Shaw Brook Culvert Structural Impact Assessment

Project:	Christie Advanced Scanning and Imaging Centre Development		
Our reference:	CASICD-MMD-XX-XX-RP-S-000005	Your reference:	
Prepared by:	C Smith	Date:	11/12/2025
Approved by:	J Kirkham	Checked by:	A Simpson
Subject:	Structural Impact Assessment of Proposed Works on Shaw Brook Culvert

Figure 1.1: Proximity of Shaw Brook Culvert to the Development

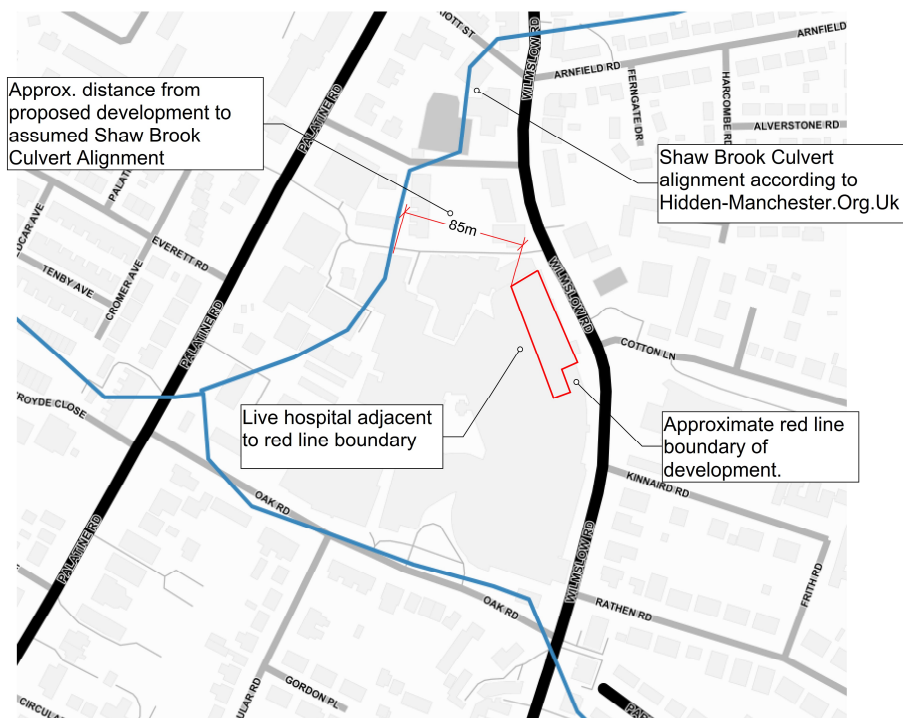
"MCC records highlight that the underground Shaw Brook culvert (1280mm x 900mm) is located within close proximity to the site (approximately 50m to the west of the site), while our records are frequently updated to ensure the highest level of accuracy, the records cannot guarantee 100% accuracy for all MCC underground assets. Therefore, we would request that the applicant informs the onsite contractor to remain observant and to take the appropriate safety precautions during excavation works. If any major unknown drainage assets are found beneath the site, then further investigation works should take place to identify the asset and MCC should be contacted immediately."

The exact alignment and setting out of the Shaw Brook Culvert is not known. MCC indicate that the culvert is 50m west of the site. Hidden-Manchester.Org.Uk shows an indicative alignment of the culvert. The proposed development red line boundary has been superimposed on this map to get an approximate distance of 85m (See Figure 1.1).

Given that the Shaw Brook Culvert is estimated to be in the region of 85m from the red line boundary of the development, the mitigation measures that will be put in place to limit vibration and damage to the live hospital between the culvert and the works area are also deemed to mitigate any risks of damaging the Shaw Brook Culvert. Details of the Shaw Brook Culvert will be included on the proposed substructure drawings and included within hazard risk assessments to ensure the Contractor is aware of the Shaw Brook Culvert and to remain vigilant during construction for unknown drainage assets.
